DEPARTMENT OF PLANNING AND PERMITTING
CITY AND COUNTY OF HONOLULU

SUBJECT: Application for an Interim Planned Development-Transit
(IPD-T) and Special District Permit No. 2020/SDD-45
Project: Ala Moana Plaza Mixed-Use Project
Landowner: GGP Ala Moana, LLC
Applicant: Brookfield Properties
Agent: R. M. Towill Corporation (Keith Kurahashi)
Location: 451 Piikoi Street - Ala Moana
Tax Map Key: 2-3-038: 003 and portion of 014
Acceptance Date: August 14, 2020

Interim Planned Development-Transit (IPD-T) No. 2020/SDD-45

Ground Floor (Level 1) Conceptual Plan

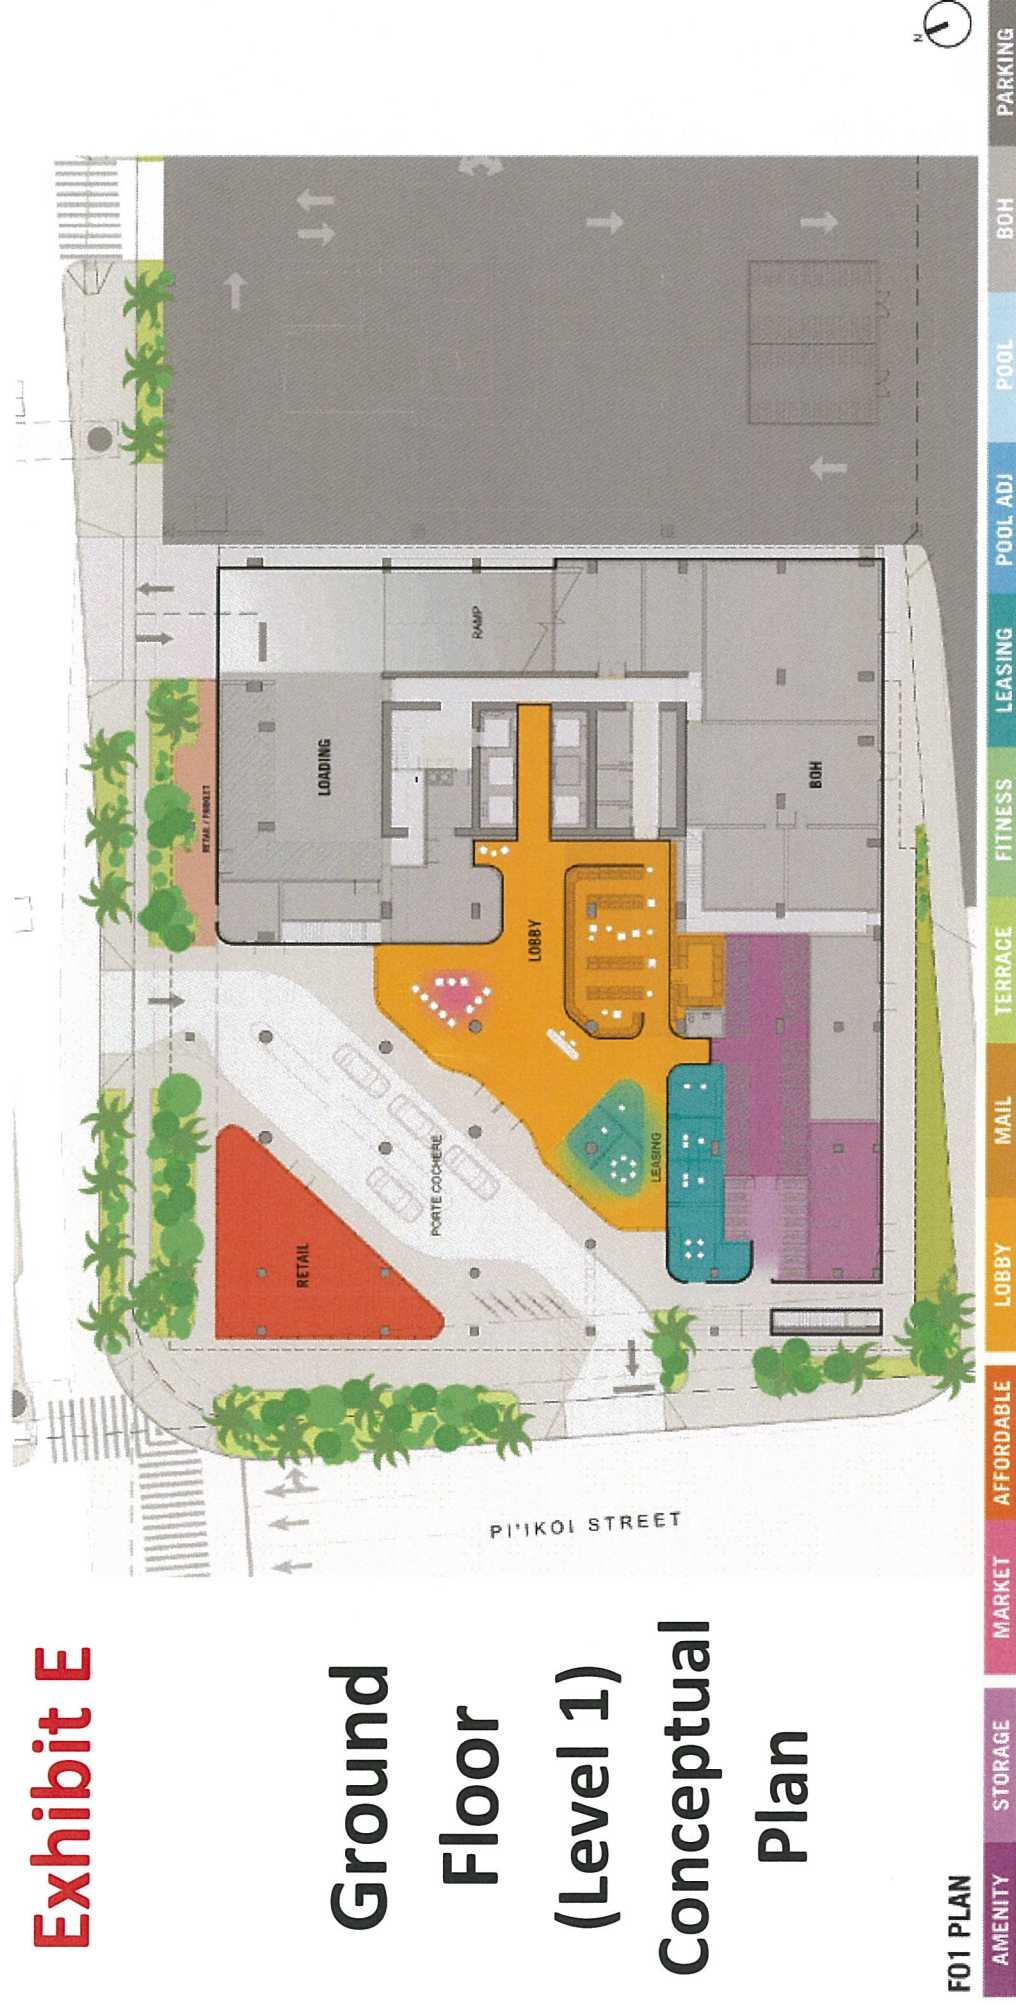
7. Parking and Loading: The off-street parking requirements and provisions are summarized in the following table. The parking and loading plans are shown in Exhibits D, F and G.

Exhibit H

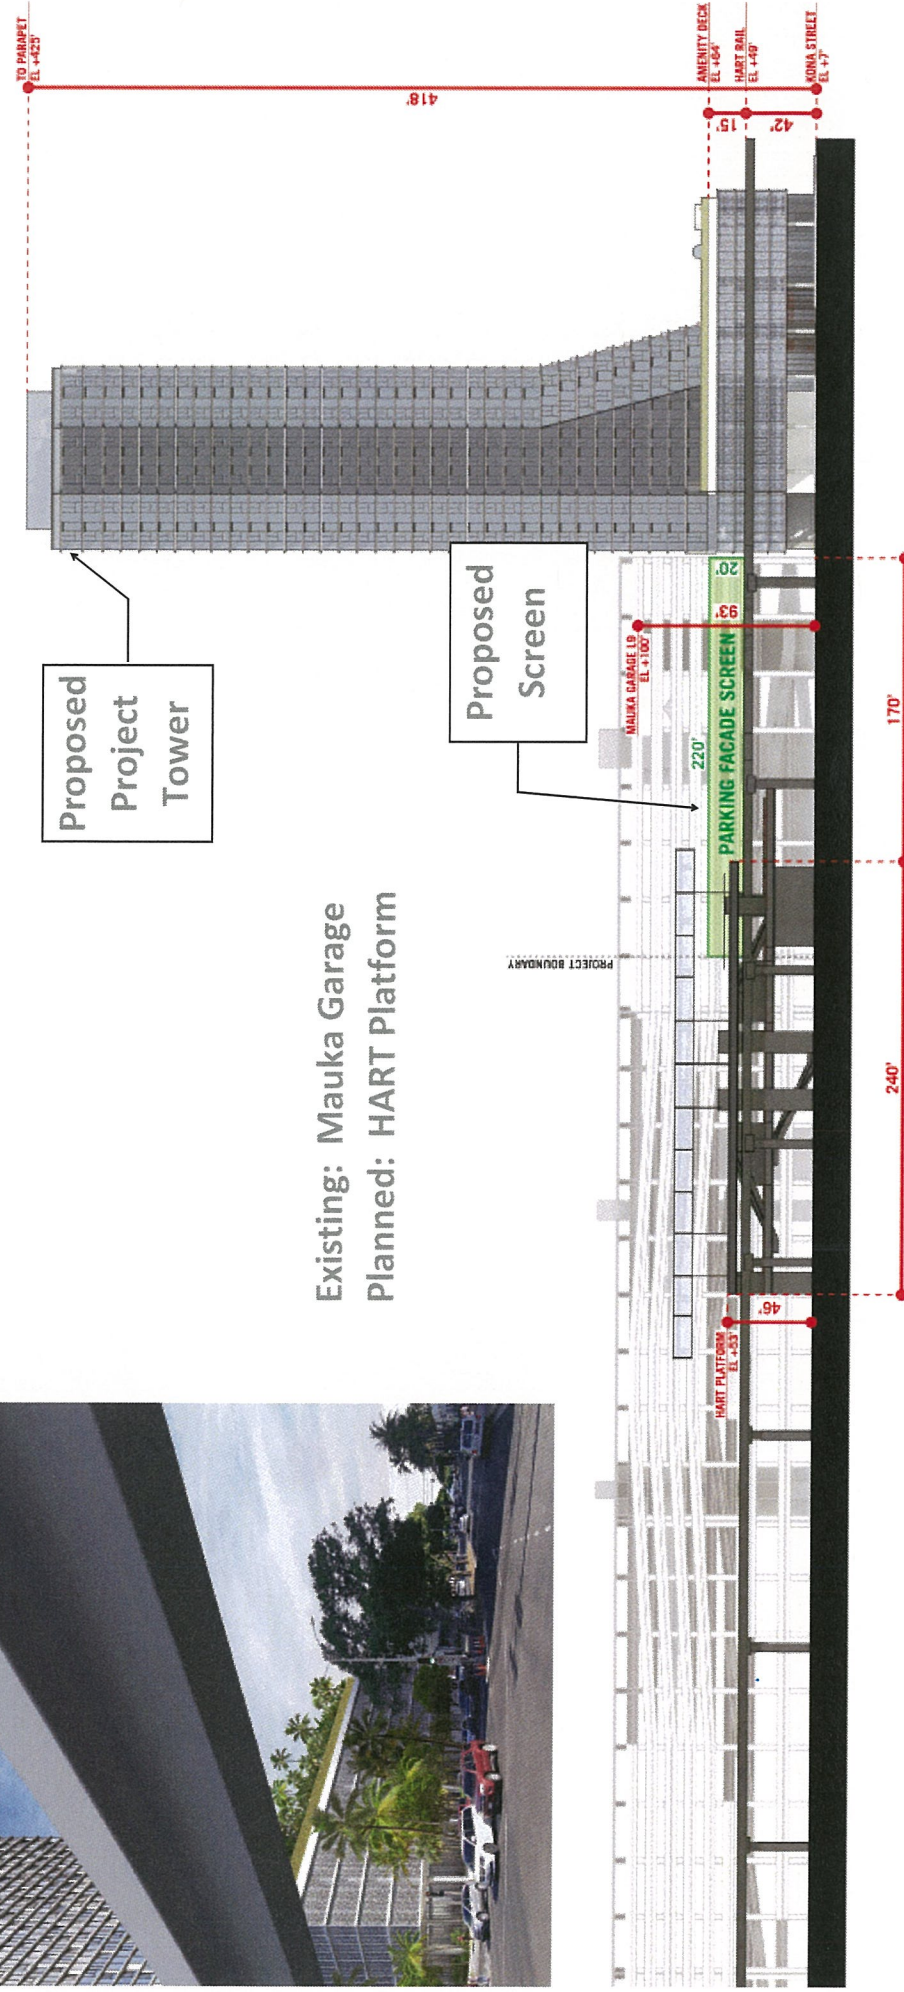
Additionally, the LUO requires screening of parking structures. The Applicant proposes screening on the mauka garage on the anticipated concourse level, but not at the ground level (see Exhibit H). In order to satisfy the intent of LUO Section 21-4.70(c), the blank wall of the loading area, parking garage, and parking podium should be screened with green walls, hanging plants, or an architecturally integrated false façade. The AMC parking structure extends far beyond the Project area, so this screening may be limited to the extent of the station along Kona Street. This will be consistent with the TOD Design Guidelines to adequately screen and buffer the parking structure visible on the concourse level and on the ground level ewa toward Piikoi Street.

The design elements screening the existing mauka garage should be integrated with the Project concept visually and should have similar treatment to the proposed podium. The screening should incorporate openings for clearly designated pedestrian and bicycle paths and entrances. Detailed landscaping, outdoor furniture, and screening plans will be reviewed and approved during the SD Permit process. Revised plans and detailed specifications should be submitted with the SD Permit application as a condition of approval.

3. Any outdoor dining features and street furniture (as applicable);
 4. Landscaping and screening, consisting of a green wall, hanging plants, or an architecturally integrated false façade to screen any existing or proposed parking structures on the ground floor and concourse level;

Planned HART Rail-Proposed Project Podium Rendering (Separation Distances)

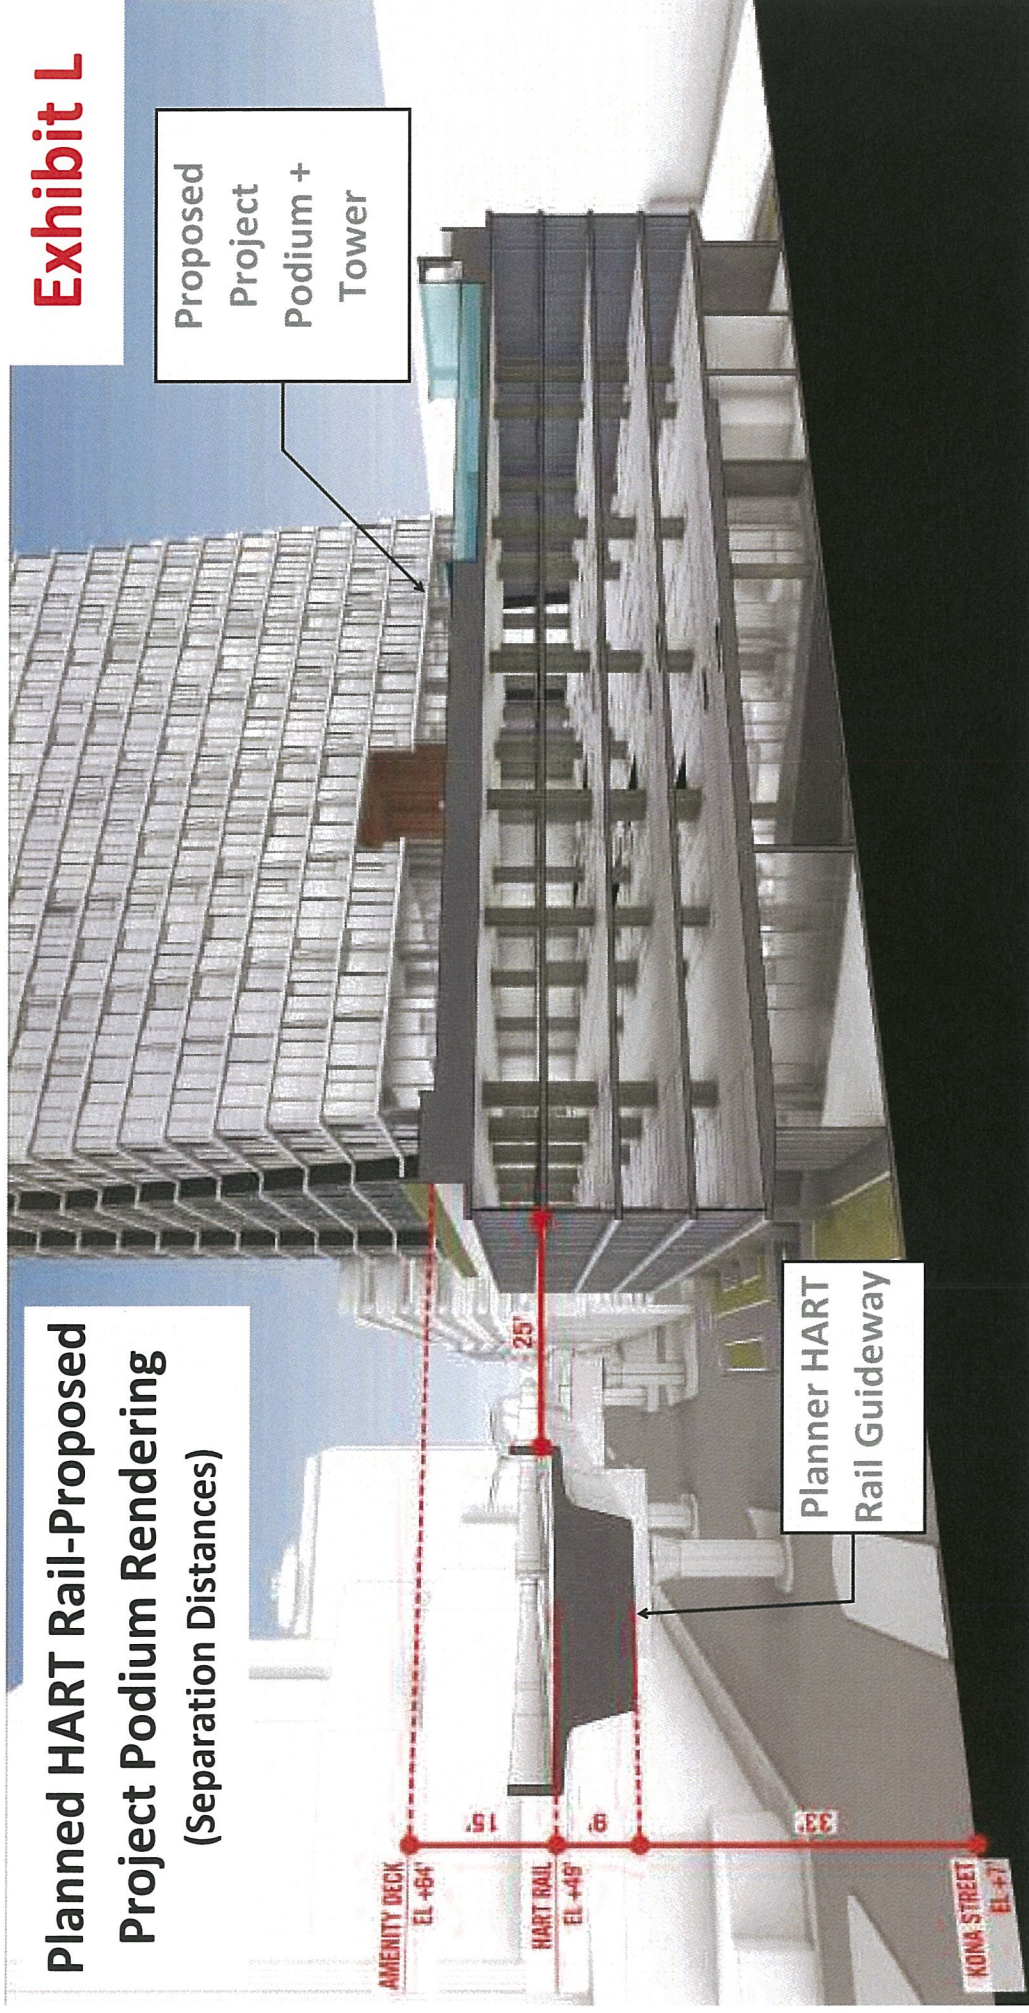
The site is approximately 180 feet from the planned HART Kalia station and will be directly adjacent to the elevated rail guideway (see Exhibit L), which will run along Kona Street with a terminus near the Kona Iki Street intersection. In the Ala Moana Neighborhood, six IPD-T projects have been approved and one other is currently under review by the City Council. Two of the proposed IPD-T Projects are proposed between Kona Street and Kapiolani Boulevard to the east of the site. The closest residential towers are located across Piikoi Street (11-story Hale Kewalo Apartment) and across Kona Street (29-story Uraku Tower). Other high-rise residential towers (40-story Hawaiki and Moana Pacific Twin Towers) are located less than one-quarter mile from the site.

Tower Separation - Distance from Closest Neighboring Towers

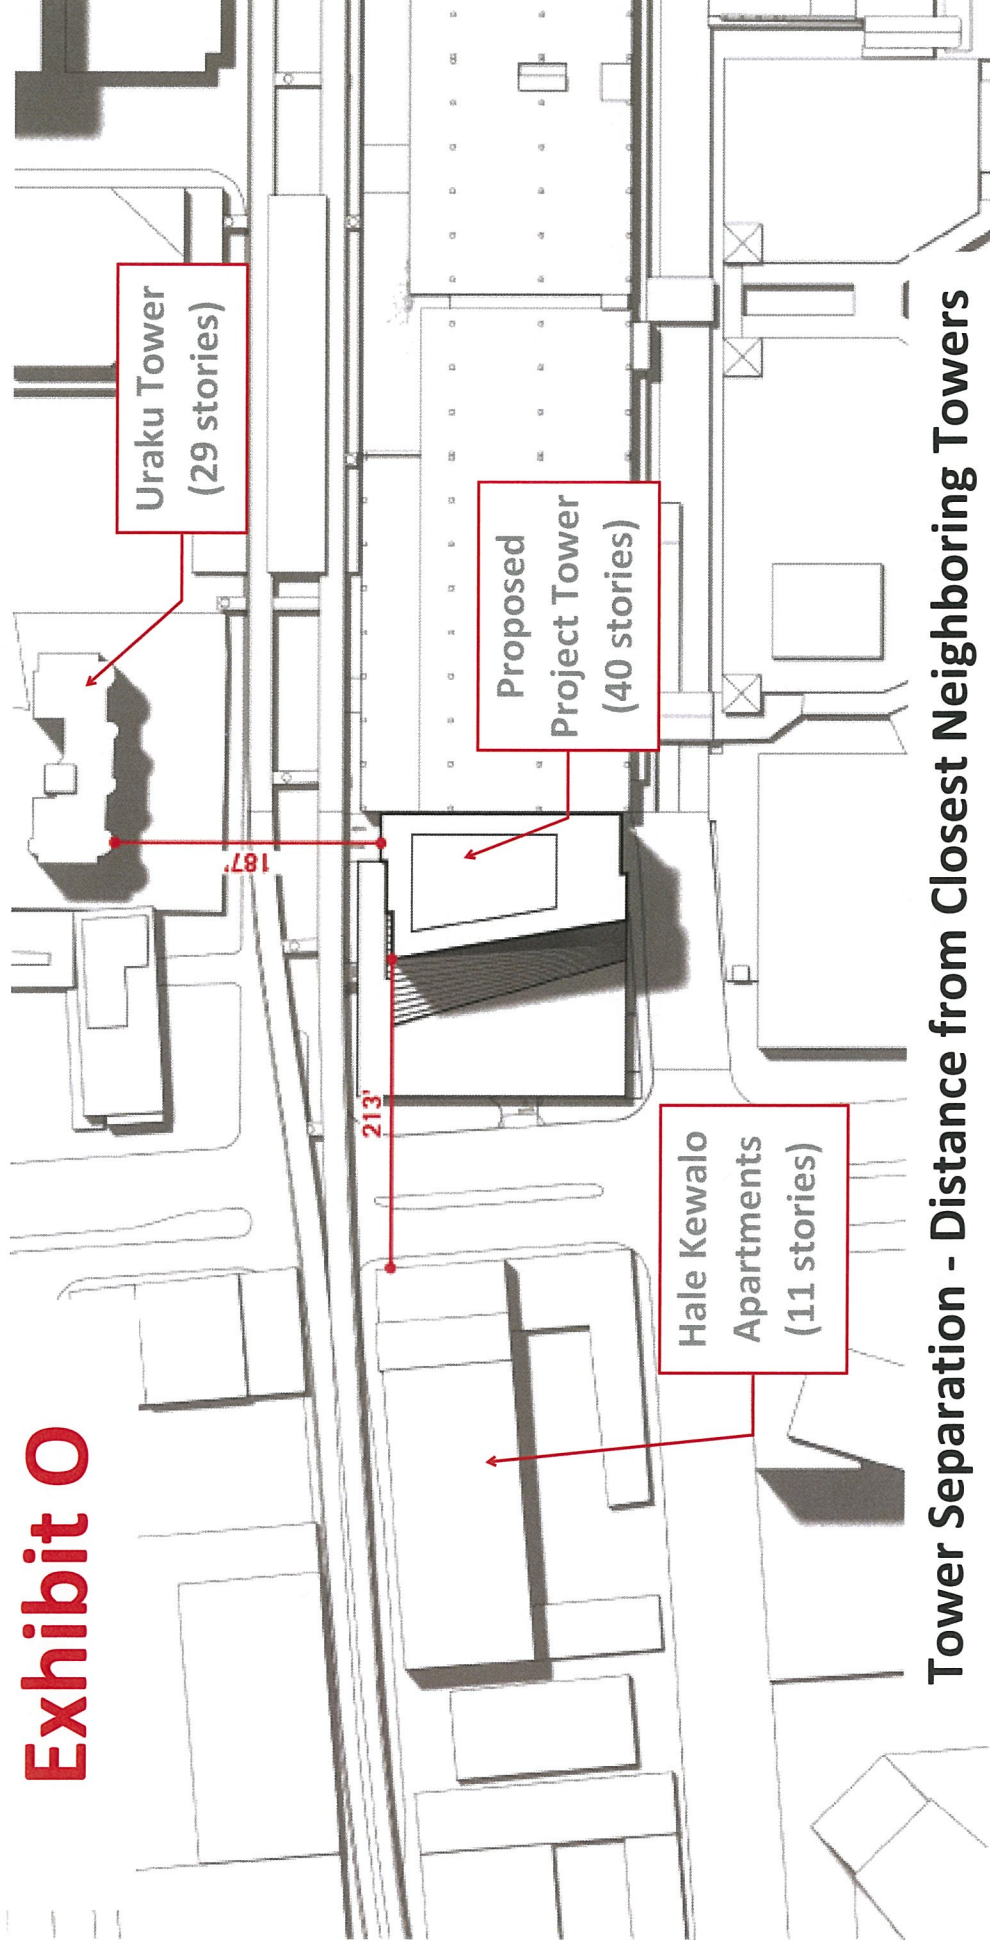
- a. Tower Separation: The TOD Plan recommends a minimum separation between tall buildings of 100 feet. The proposed tower is approximately 187 feet from Uraku Tower (29 stories) and 213 feet from the Hale Kewalo Apartments (11 stories) across Piikoi Street (see Exhibit O). The closest 400-foot-high towers in the vicinity are the Moana Pacific Tower (west) and Hawaiki Tower, which are approximately 750 feet and 300 feet from the site, respectively. Thus, the Project complies with this TOD Plan recommendation.
